# Environmental Impact Statement

Response Document

Project EnergyConnect (the Project) is a proposed high-voltage electricity transmission interconnector to be built between South Australia and New South Wales, with a spur line to Victoria.

**Sheet 2**  
**Proposed project laydown areas**

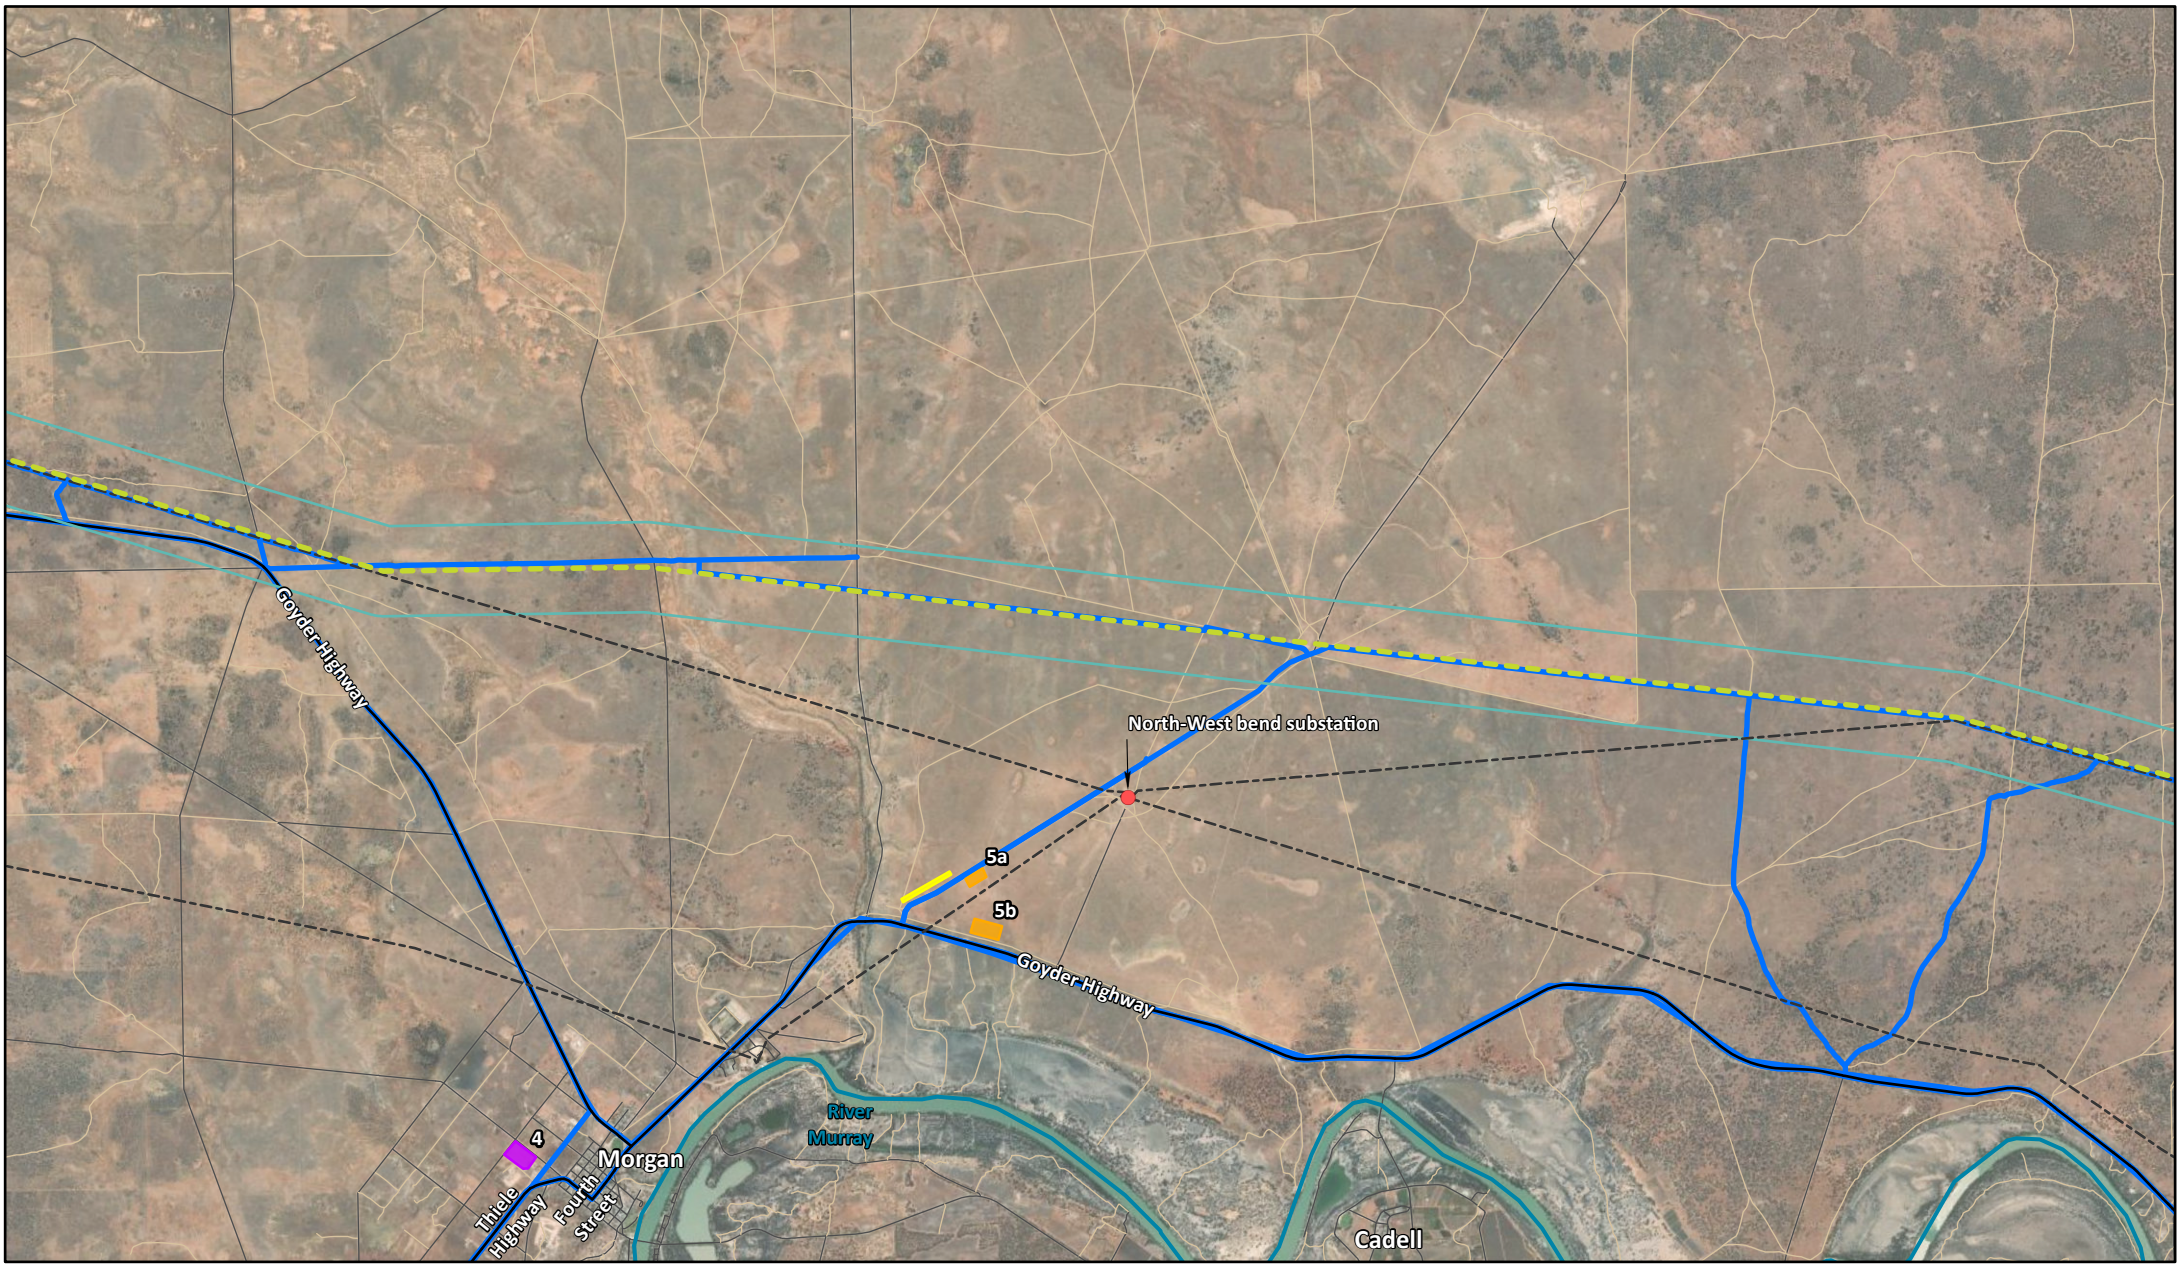
- Central part:
  - Goyder HWY Laydown (Figure 2 - Sheet 2 ID #3a & 3b); S44 H201000 (CT6213/691)
  - North West Bend Laydown (Figure 2 - Sheet 3 ID #5a & 5b); Woods and Forest Road; S21 H760400 (CT6154/657)

**Sheet 3**  
**Proposed project laydown areas**

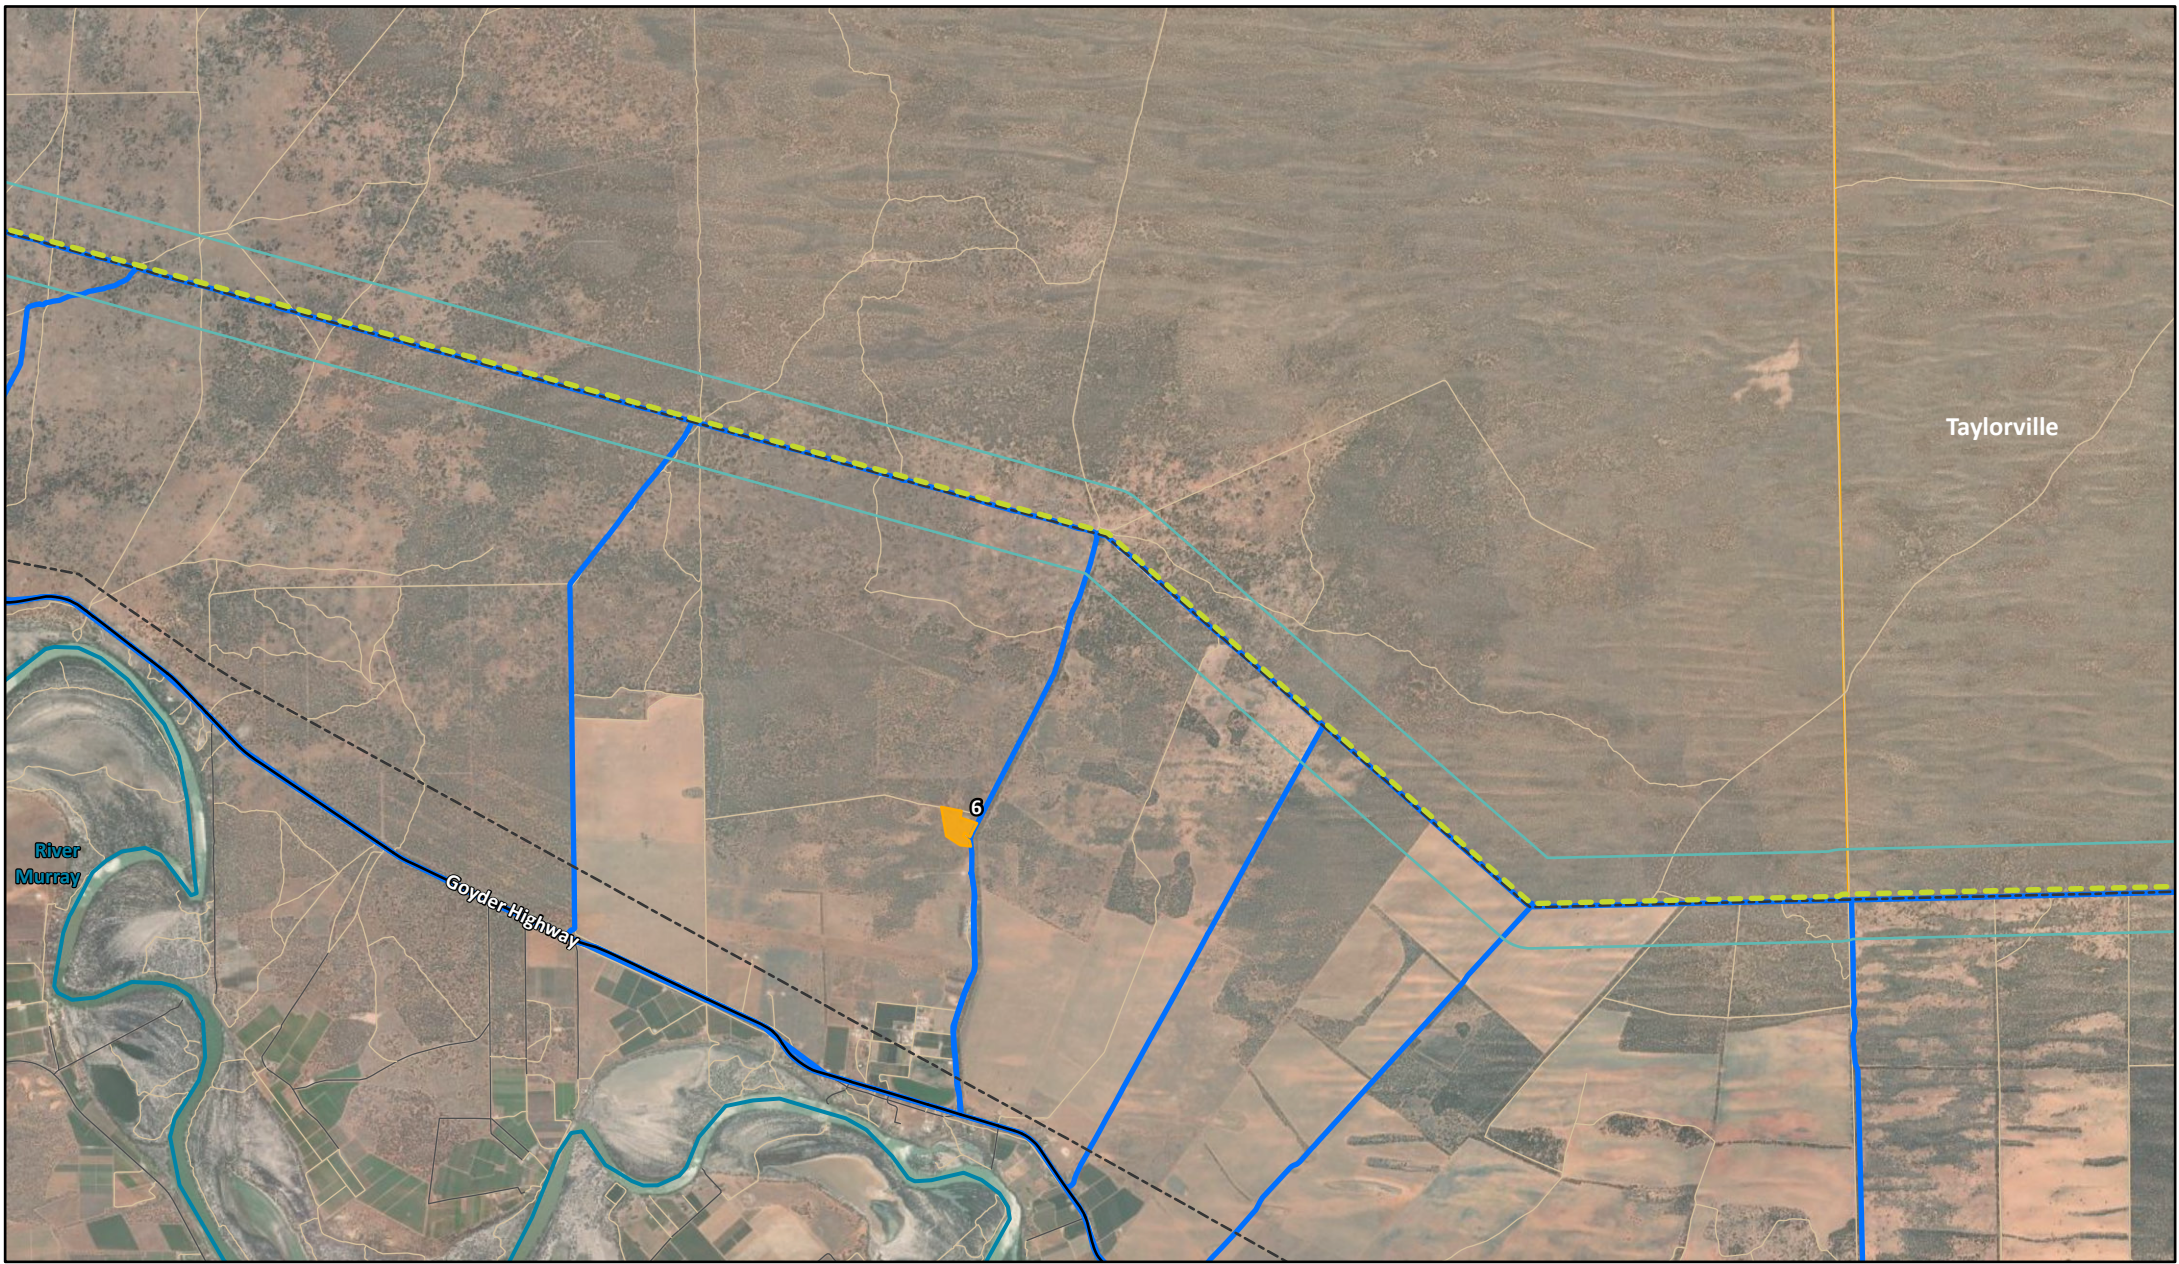
As discussed within the EIS, workers accommodation will be required for the Project. The EIS identified four potential areas for temporary worker accommodation, including a Morgan option. The accommodation strategy has continued to develop since the finalisation of the EIS. It has been identified that the Project will need a camp and associated accommodation facilities for approximately 120 workers to be constructed in Morgan to service the Western part of the Project. The camp will be located at 23 Centenary Road Morgan; Sec 35 & 36 Hundred of Eba (CT 5819/810), and is referenced in Figure 2, Sheet 3 ID #4.

**Sheet 4**  
**Proposed project laydown areas**

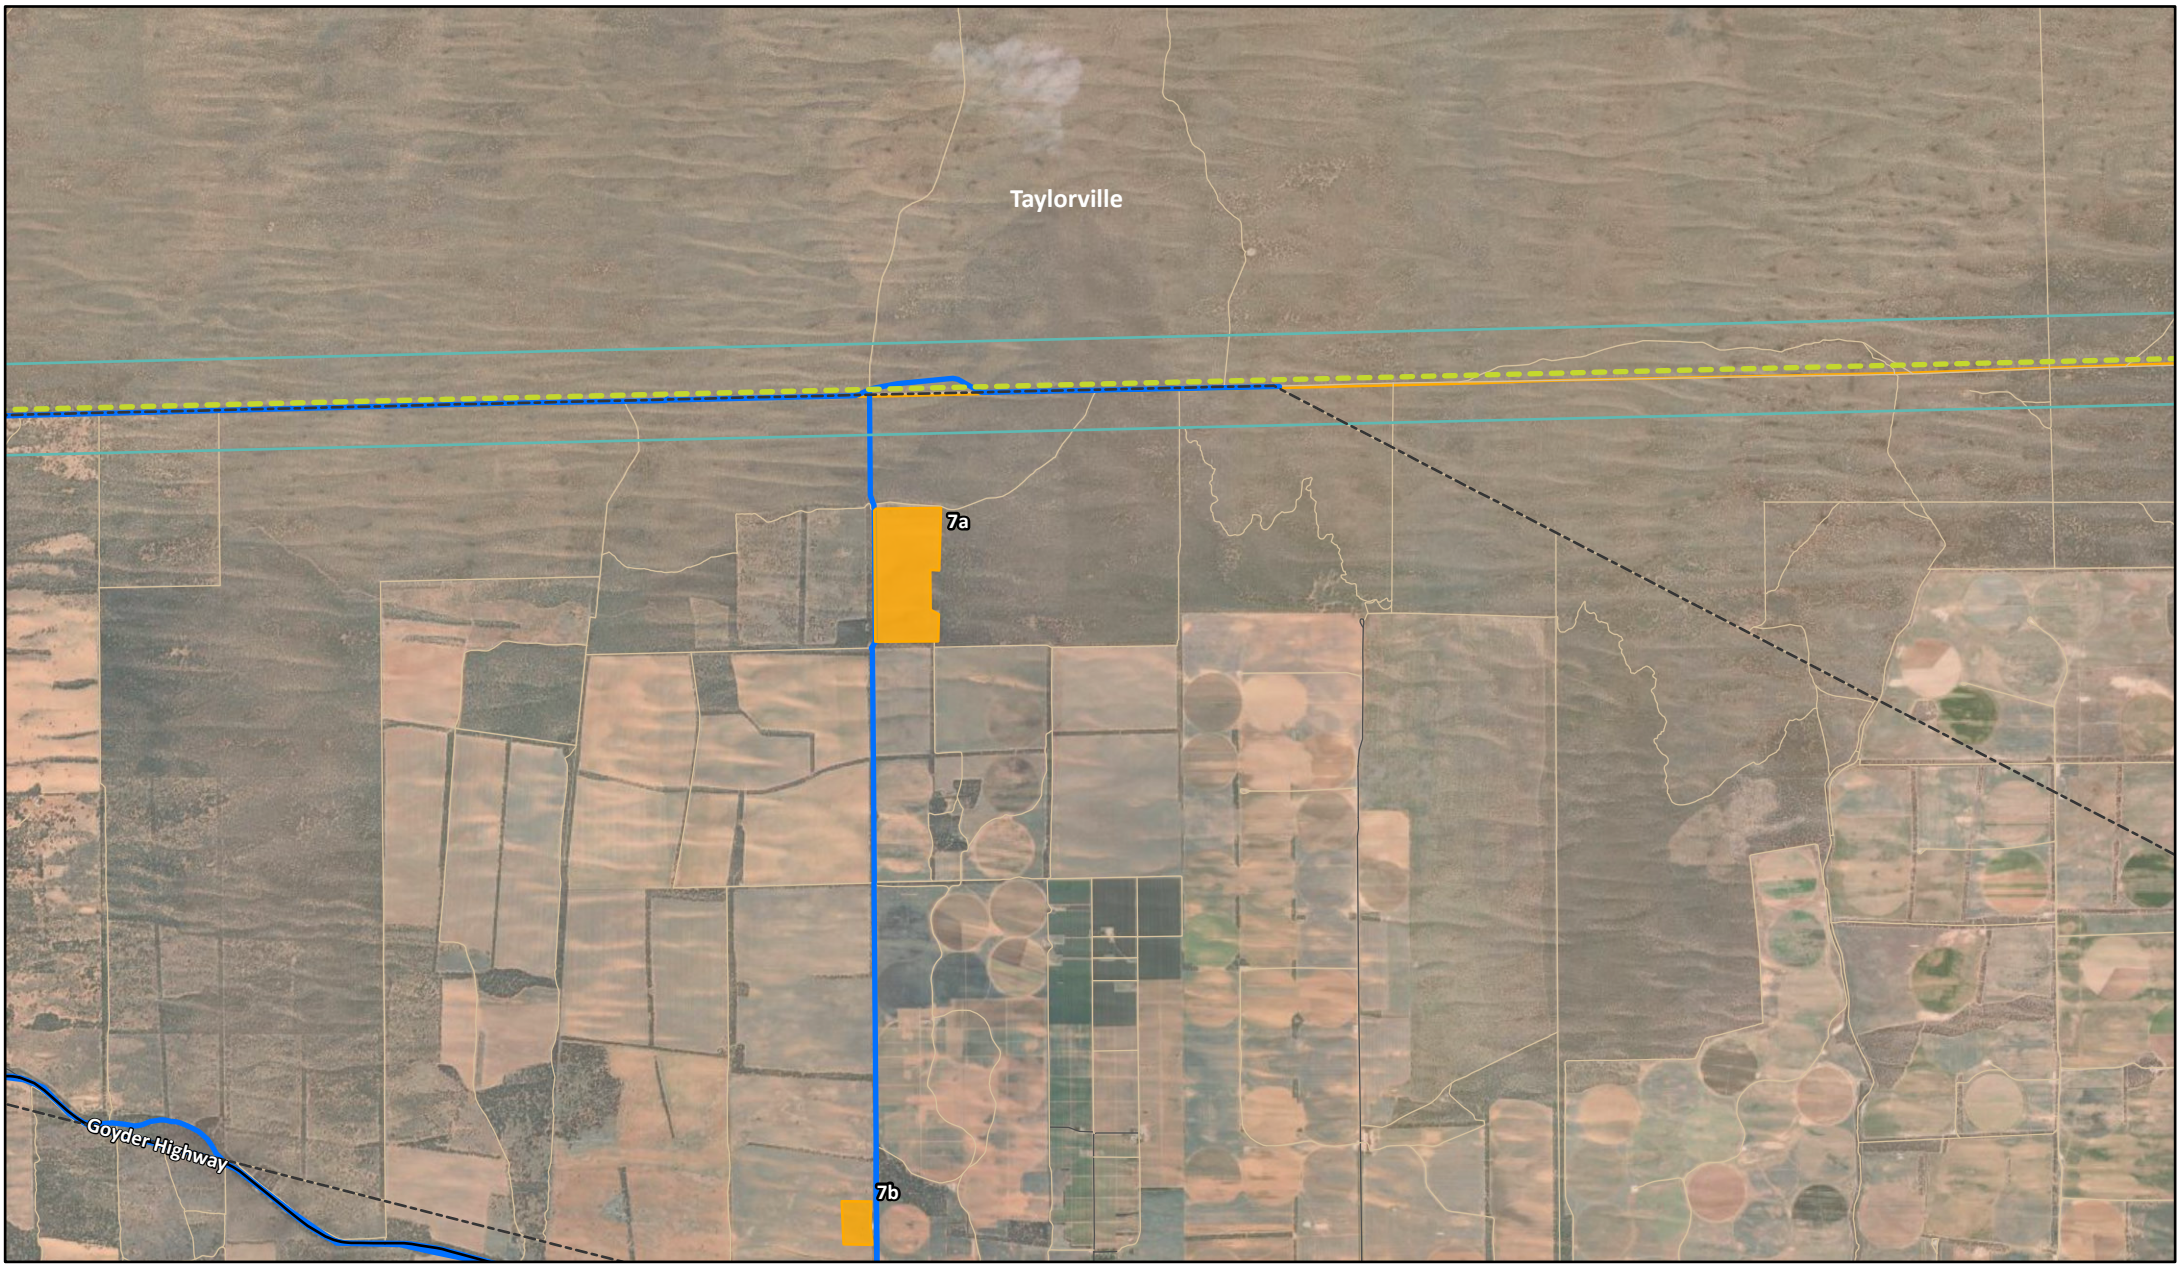
- Lunn Road Laydown including helicopter landing facility (Figure 2 - Sheet 4 ID #6); QP93 D92913 (CT6139/782)
  - Devlins Pound (Loffler Road) Laydown including helicopter landing facility (Figure 2 - Sheet 5 ID #7a & 7b); S12 H760300 (CT 6190/851; North); S28 H76030 (CL 6202/737; South)
